**Environmental
Planning
Commission**

Staff Report

Agenda Number: 4
Project #: PR-2022-007103
Case #s: SI-2023-0691, SI-2023-00693
Hearing Date: June 15, 2023

Agent	Tierra West, LLC
Applicant	ABQ Terminal LLC, Attn: LB Walker & Associates, Inc.
Request	Site Plan-EPC & Variance-EPC
Legal Description	All or a portion of Map 44 Tract 64C2, excluding 0.30 acres and excluding all of Tract 64C3A2
Location	3200 Broadway Blvd. SE, west of Arno St. SE and south of Wesmeco Dr. SE
Size	Approximately 22 acres
Existing Zoning	NR-LM

TRAVEL CENTER/FUEL DEPOT BROADWAY/SUNPORT BLVD	DRAWN BY SB
	OVERALL SITE PLAN	DATE 05-30-23
05/30/2023 RONALD R. BOHANNAN P.E. #7868	 5571 MIDWAY PARK PLACE NE ALBUQUERQUE, NM 87109 (505) 858-3100 www.tierrowestllc.com	SHEET # SP-1
		JOB # 2022031

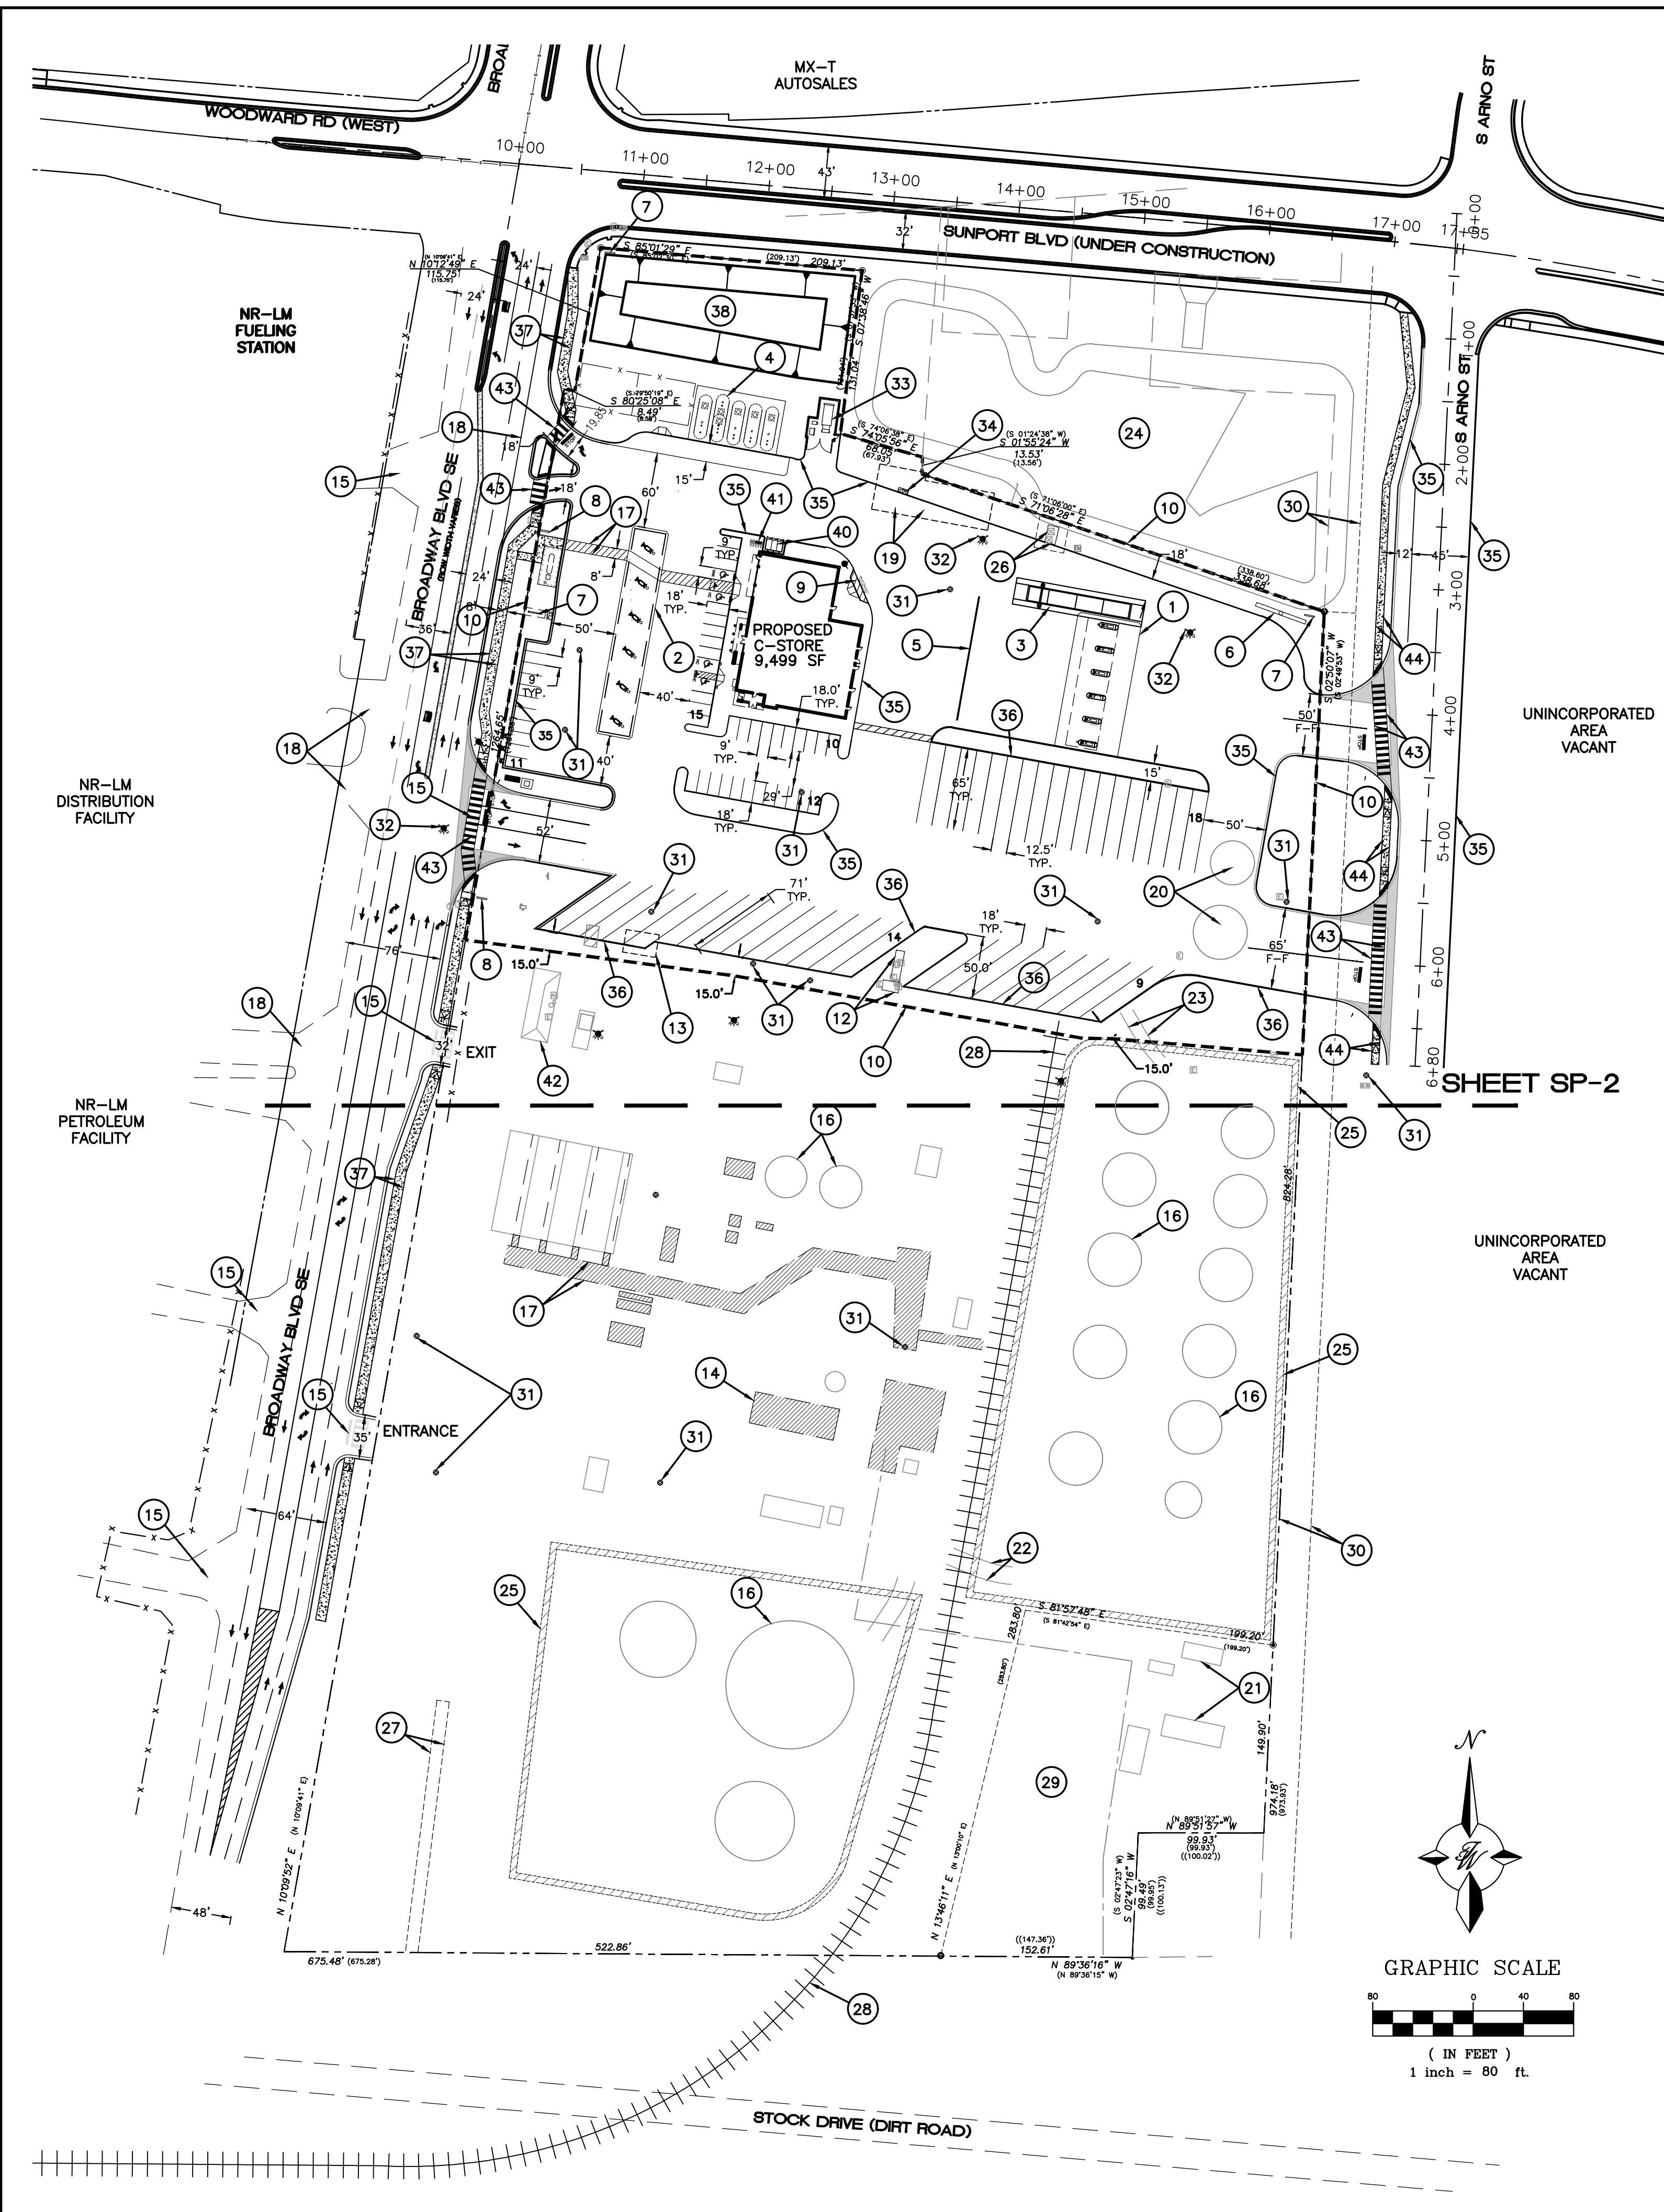
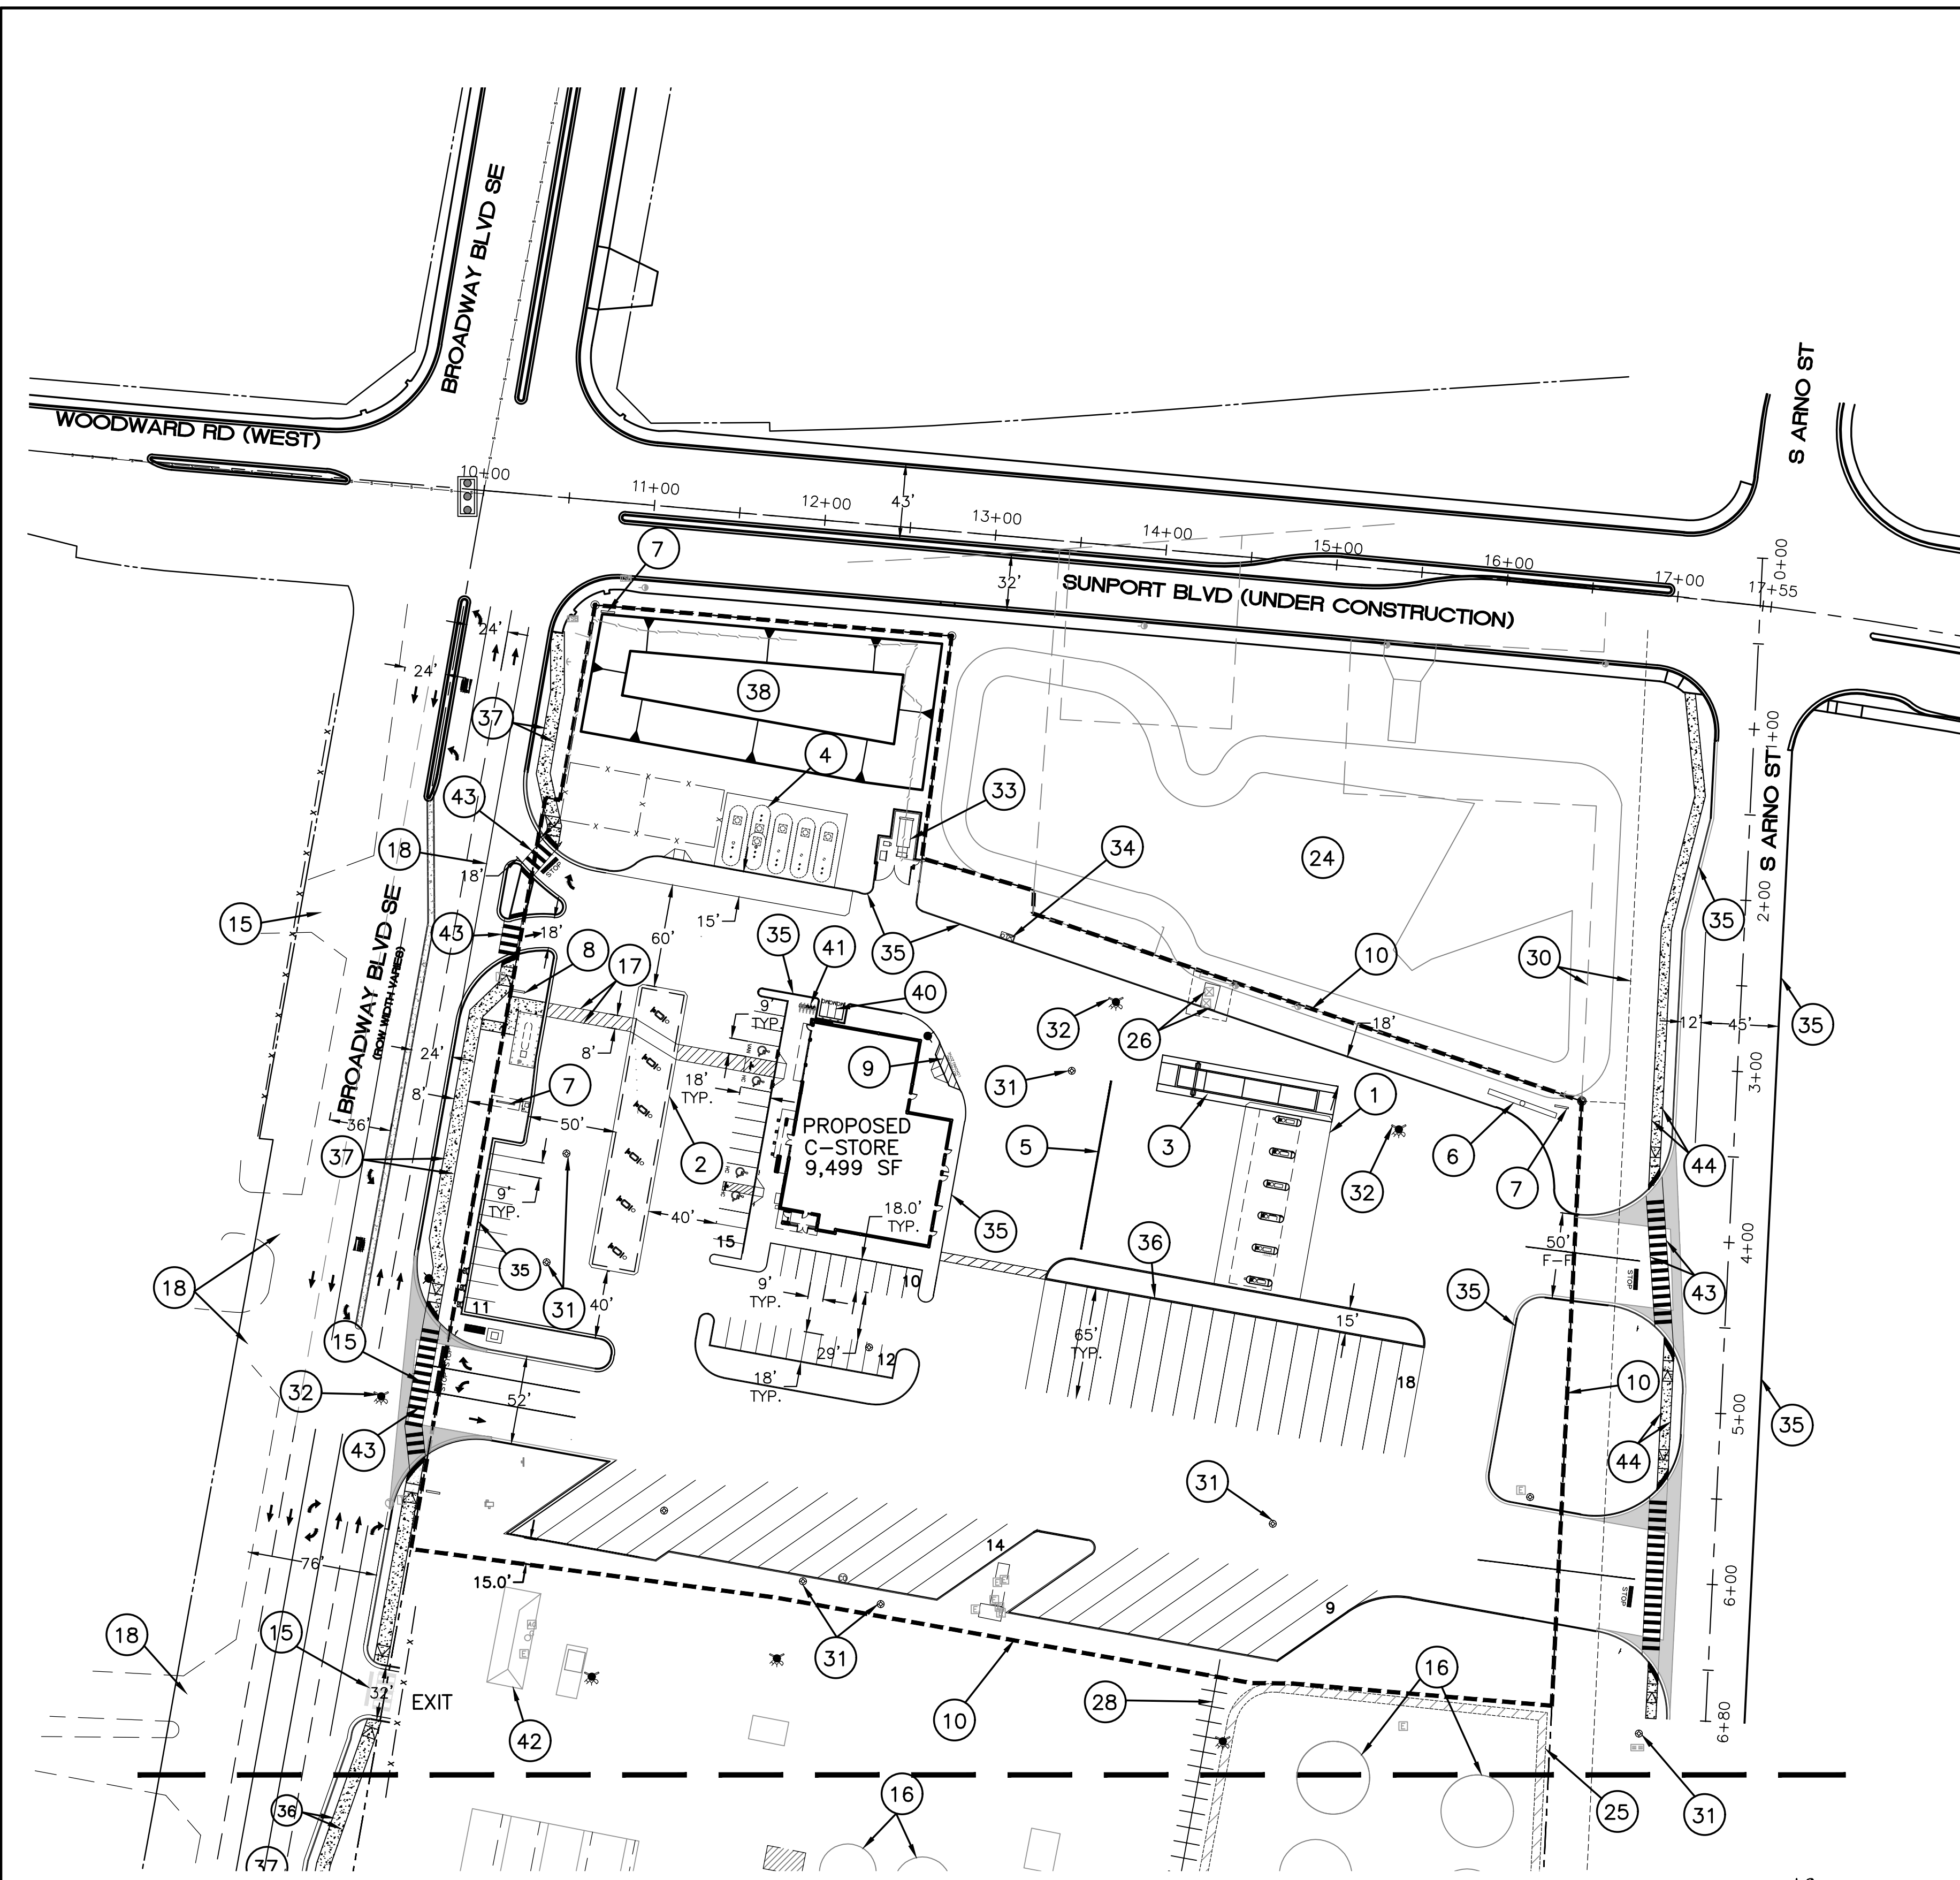
- a. The index to drawings shall include SP3 and all sheets associated with the request.
 - b. The 0.30 tract that is excluded in the legal description on the southern portion of the site shall be highlighted and referenced as “not included” on the overall site plan sheet and on the Fueling Depot As Built site plan sheet 3.

- c. Pursuant to IDO 6-6(N)(2)(f) Any Variances granted that are associated with the Site Plan shall be noted on the approved Site Plan sheet 1 and sign detail sheets.

TRAVEL CENTER/FUEL DEPOT BROADWAY/SUNPORT BLVD	DRAWN BY SB
	TRAVEL CENTER SITE PLAN	DATE 05-30-23
05/30/2023 RONALD R. BOHANNAN P.E. #7868	TIERRA WEST, LLC 5571 MIDWAY PARK PLACE NE ALBUQUERQUE, NM 87109 (505) 858-3100 www.tierrawestllc.com	SHEET # SP-2
		JOB # 2022031

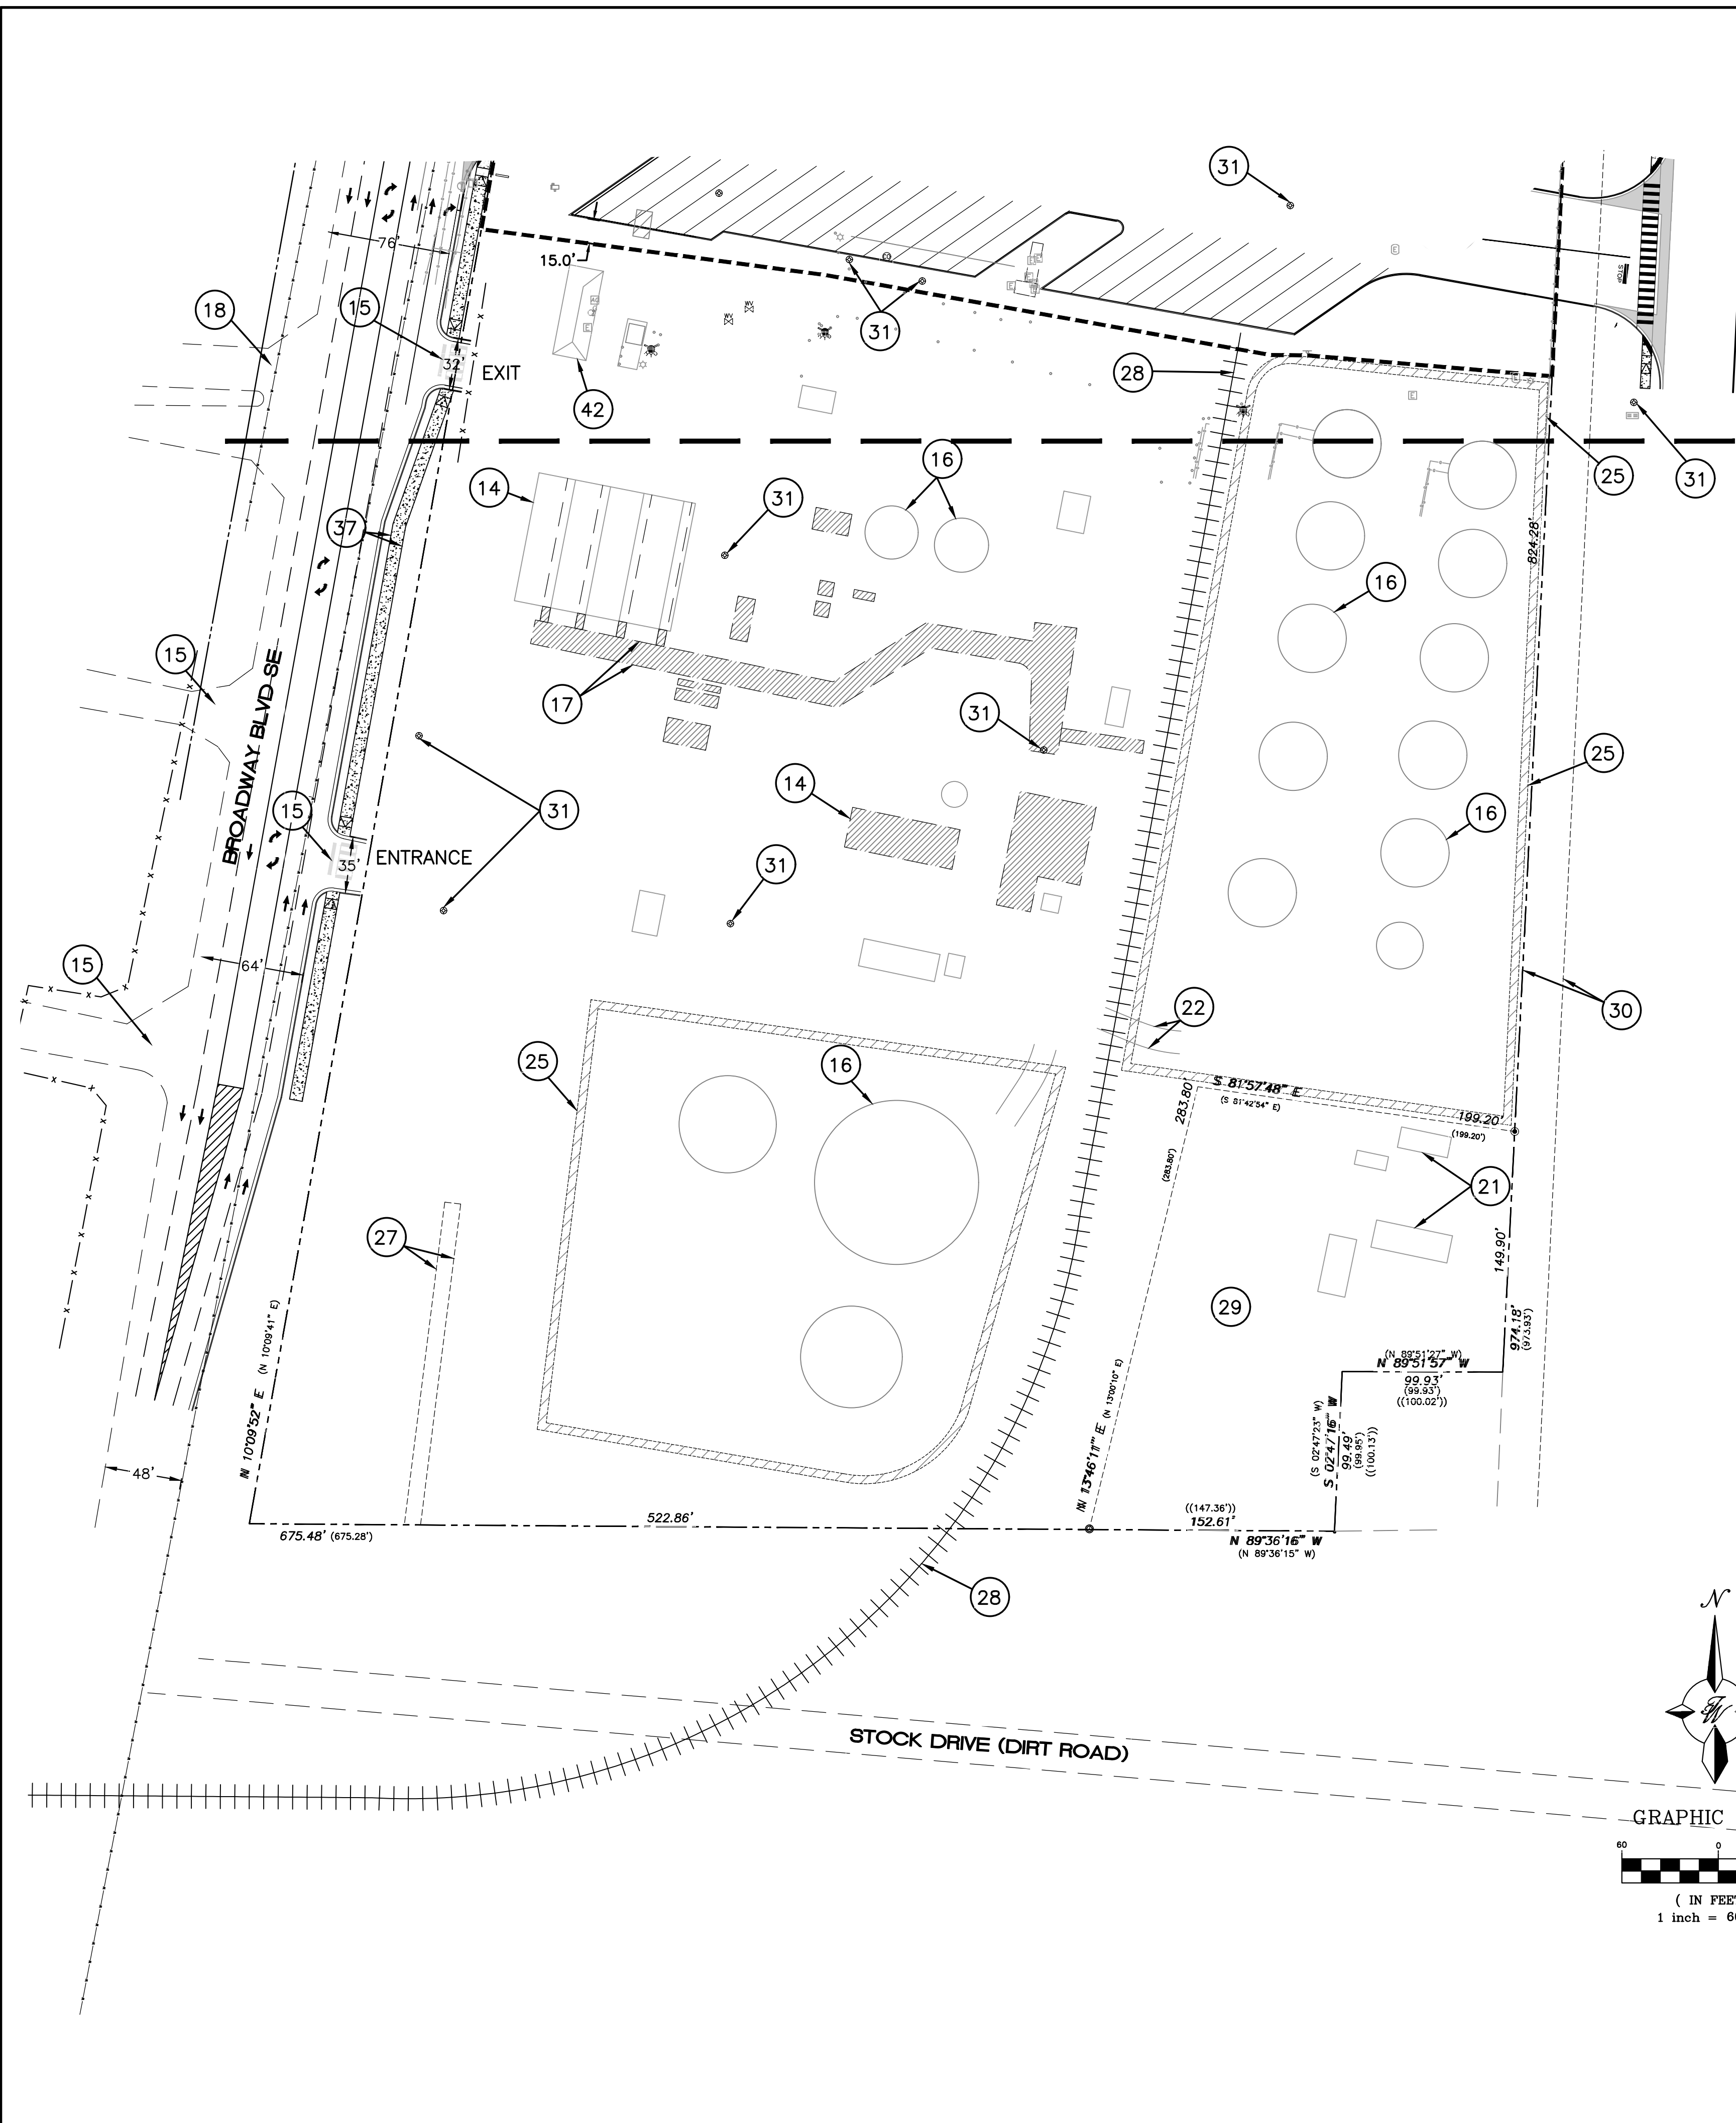
- c. The title of Site Plan sheet 3 for the Fueling depot shall be changed to “As built Site Plan.

- d) Please Change all references to Loves to “Travel Center” and all references to Musket to “Fueling Depot” we don’t use brand names at EPC. EPC is strictly land use.
- e) Change the title of the sheet to “As built Site Plan”
- f) Add a note similar to the note on sheet 1. “The existing fueling depot on the southern ~15-acre portion of the site is to remain as developed and is included in this request as an As Built Site Plan for clarity and compliance moving forward.”
